Subject: UniStar Nuclear Energy, NRC Docket No. 52-016  
Submittal of Response to Requests for Additional Information for the  
Calvert Cliffs Nuclear Power Plant, Unit 3 – RAI No. 9 RSAC 946

**Response to RAI Set Number 9 RSAC 946**

**RAI Number 02.02.03-2: FSAR Section 2.2.3**

FIGURE 1

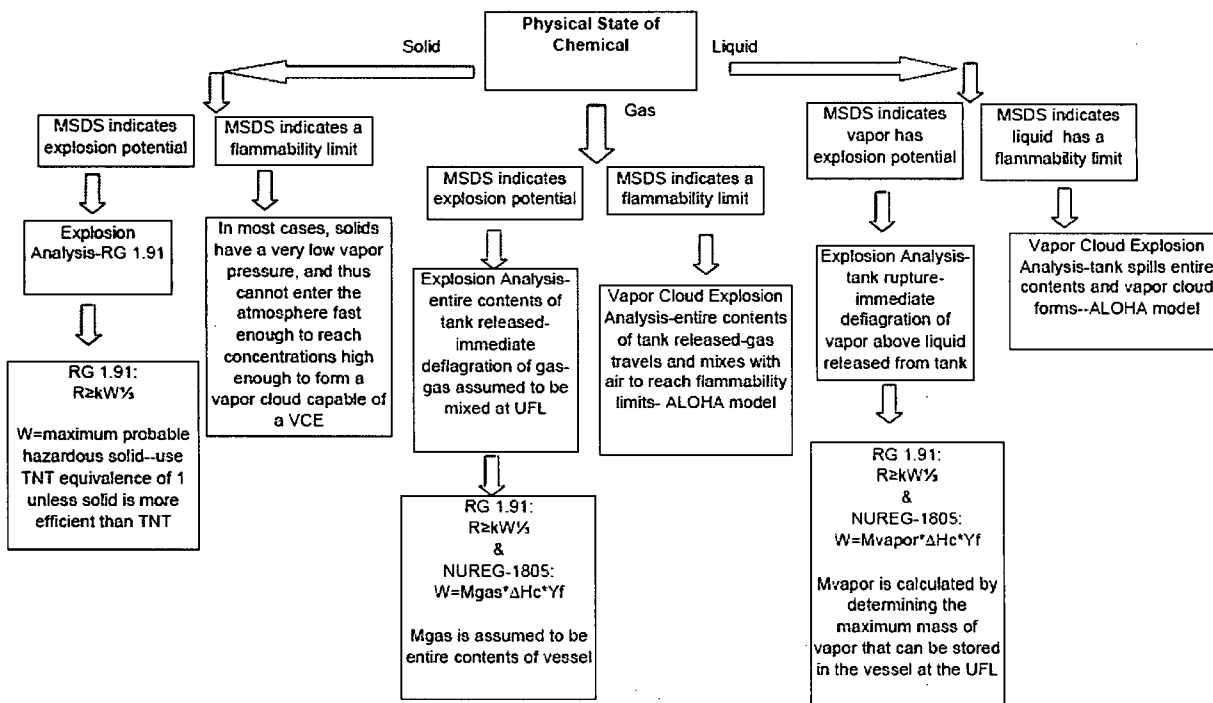
RG 1.206 provides guidance regarding the information that is needed to ensure potential hazards in the site vicinity are identified and evaluated to meet the siting criteria in 10 CFR 100.20 and 10 CFR 100.21. FSAR Section 2.2.3.1.2 does not seem to follow the referenced regulatory guide methodology. The section references Regulatory Guide 1.91, Revision 1 methodology as being used in determining the minimum safe distances. However, for the liquid chemicals stored (i.e., gasoline, toluene, etc), the applicant considered only the in-vessel confined vapor amount for potential for explosion, and the amount of vapor in the air is determined based on the equivalent of the upper flammability limit. The applicant stated that this is consistent with the NUREG-1805 methodology. NRC staff's determination of safe distance conservatively based on RG 1.91, Rev. 1 gave different results. Please provide details of the approach and methodology with a sample analyses for independent review and comparison of results.

Two explosion scenarios are evaluated for each flammable chemical capable of sustaining an explosion. The first scenario involves the rupture of a vessel in which the entire contents of the vessel are released and an immediate deflagration/detonation ensues. That is, upon immediate release, the contents of the vessel are assumed to be capable of supporting an explosion upon detonation (For flammable liquids this is only possible when part or all of the container is filled with the chemical in the gas/vapor phase between the UFL and LFL). The second scenario involves the release of the entire contents of the vessel where the gas (or vapors formed from a liquid spill) travel toward the nearest safety-related system, structure, or component and mix sufficiently with oxygen for the vapor cloud to reach concentrations between the UFL and LFL creating the conditions necessary for a vapor cloud explosion whereby detonation occurs. The methodology presented below is representative of the first scenario. (A separate methodology using the Areal Locations of Hazardous Atmospheres (ALOHA) model is used for the second scenario.) Figure 1 summarizes the decision making process/methodologies employed for the two scenarios.

Two explosion hazard scenarios are evaluated for each chemical depending on the chemical's physical properties:

- The first scenario involves the rupture of a vessel whereby the entire contents of the vessel are released and an immediate deflagration/detonation ensues.
- The second scenario involves the release of the entire contents of the vessel whereby the gas (or vapors formed from a liquid spill) travel towards the safety related system structure or component and mix sufficiently with oxygen for the vapor cloud to reach concentrations between the LFL and UFL creating the conditions necessary for a VCE whereby detonation occurs.
